CULVER AIRCRAFT CORPORATION
WICHITA, KANSAS

SERVICE MEMORANDUM

SUBJECT: Alteration and Maintenance of Cooling Baffles of Culver Model LFA (Franklin Powered).

TO: Owners of Model LFA - Serials 204 to 397.

FIGURE 1

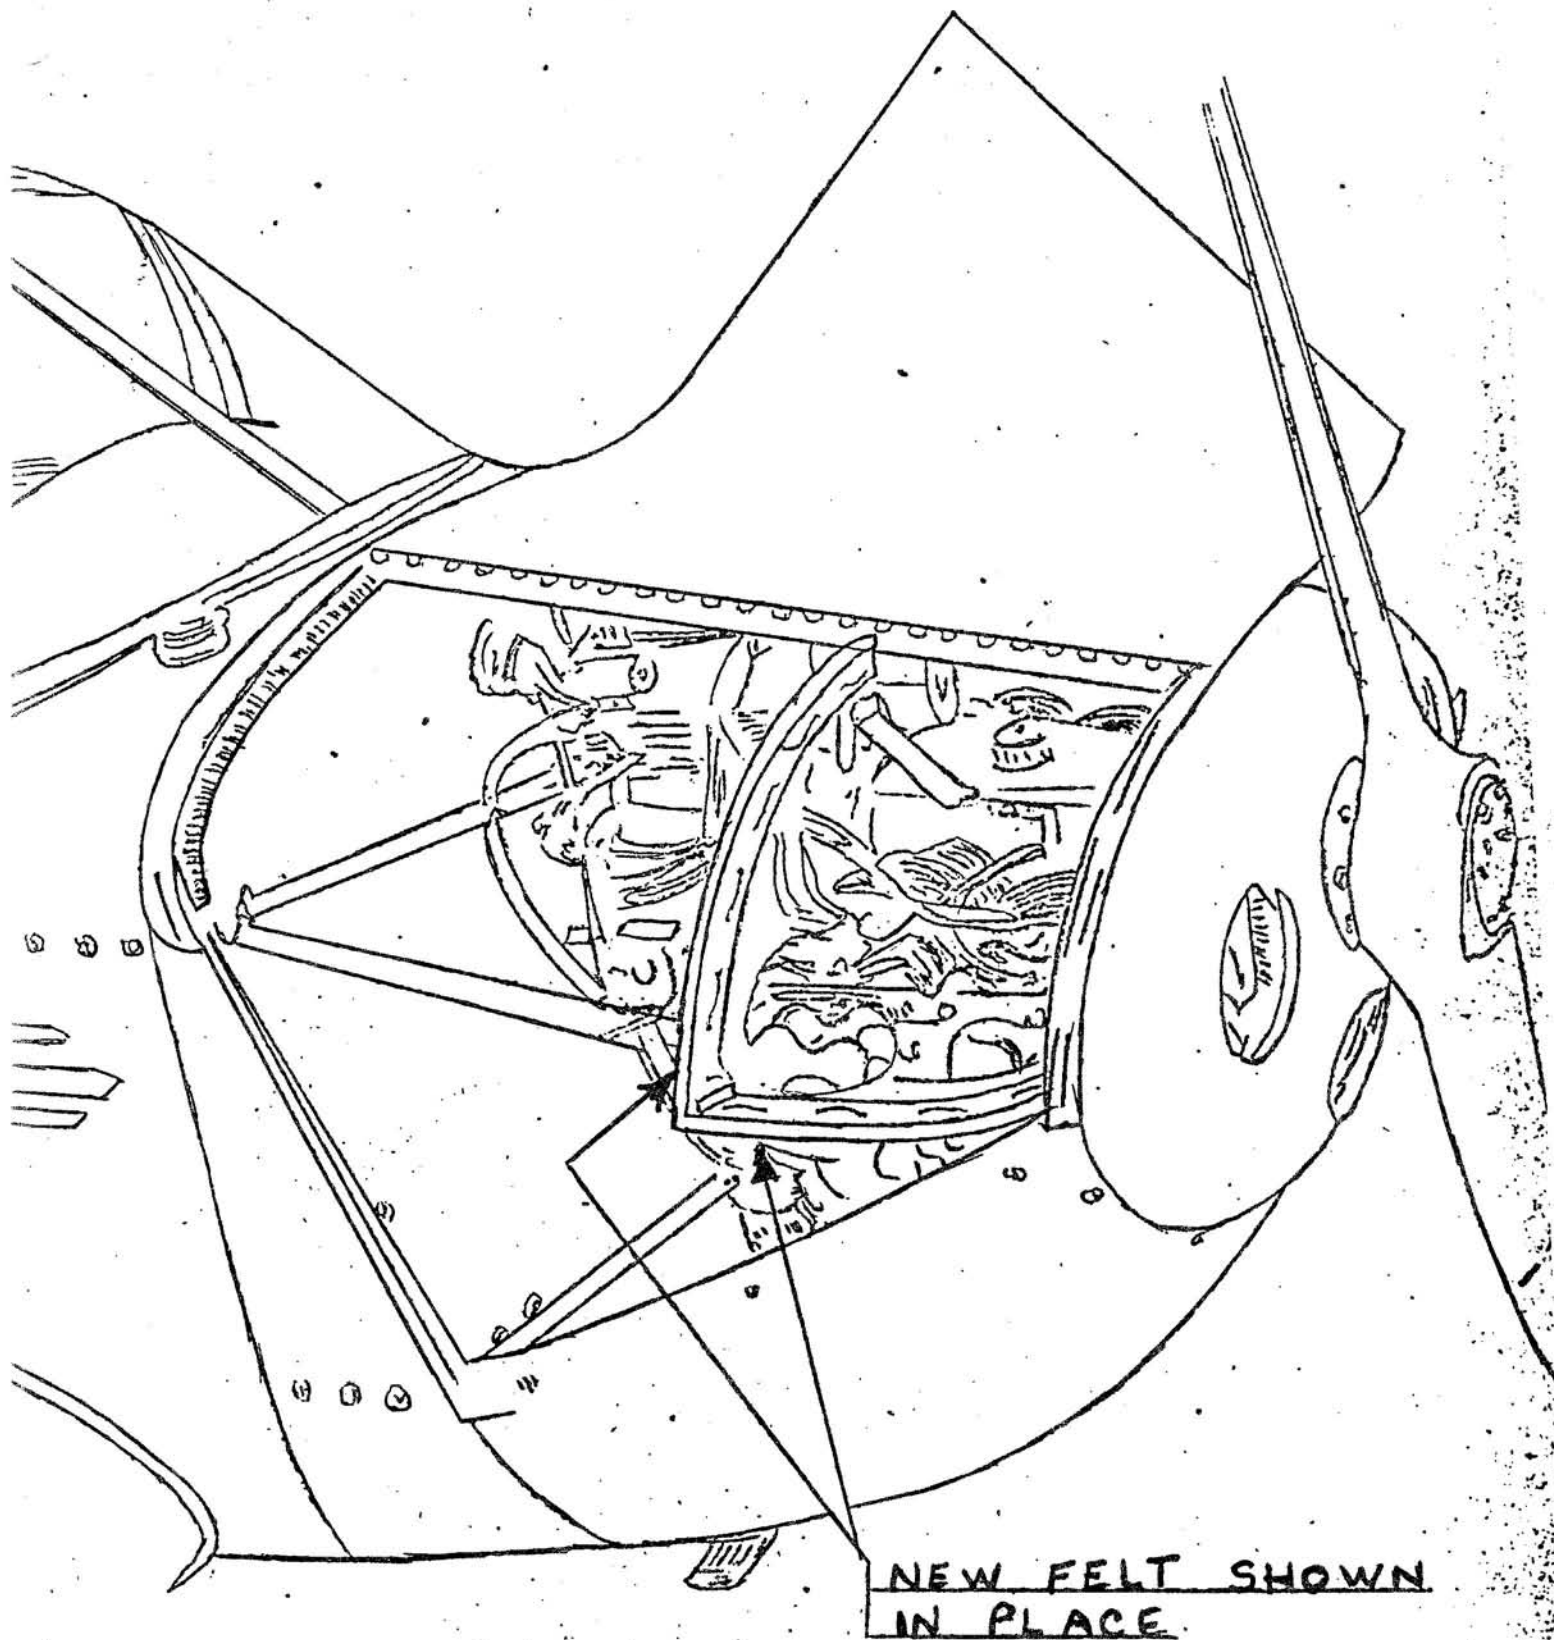
3. Service has shown that the leather facings on the baffles lose their resiliency with heat and time. To correct this situation, we strongly recommend the following procedure: Replace the leather with 1/2" thick hard felt in accordance with Figure 4, making sure that the baffle plates clear the cowling by 1/4" and that the felt extends 1/2" beyond edge of plate. To do this, nose cowl must be removed as indicated in Fig. 3 and all leather replaced by felt. SAE F-6, F-7, F-12, F-13, or F-15 is suitable for the purpose. If none of these grades may be obtained locally, the Culver Service Department will forward enough strips for one airplane at cost of \$0.85 upon request, postage prepaid. Do not use any other type of felt than specified. Figs. 1, 2, and 3 show the proper installation of the felt.
